**OLD ORCHARD BEACH  
JUNE 2018  
PLANNING BOARD  
MEMO**

# June 2018 Planning Board Memo: Table of Contents

**Proposal:** Site Plan Review: Demo existing building and construct new 7,225 sq. ft. retail building including associated parking, sidewalks and other site improvements  
**Action:** Discussion; Final Ruling  
**Owner:** Zaremba Group  
**Location:** 19 Heath St., MBL: 309-9-33, DD2

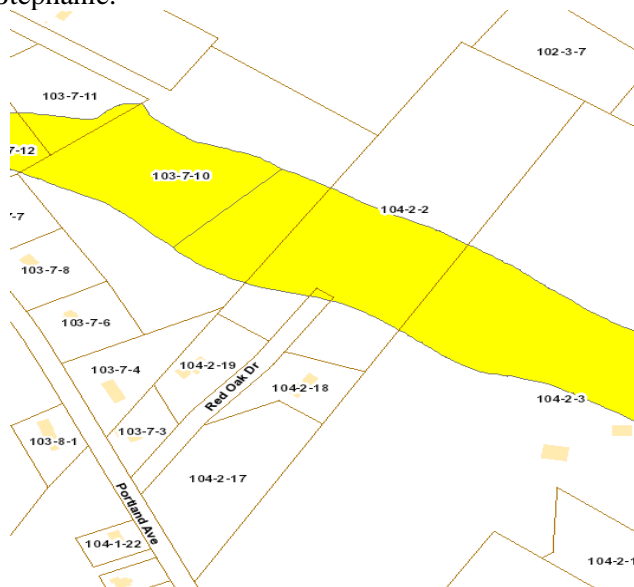
The house adjacent to Lot 9 on the other side of the stream was just completed this past summer. On the approved plans from 2005 it shows this lot as part of Phase II (*see attached plans*). In addition, the parcel number (104-2-2) on the

Town's GIS shows that house as part of the same MBL as these 9 additional units. It is unclear on the sketch plan whether this lot is considered part of Phase II as shown on the 2005 approval.
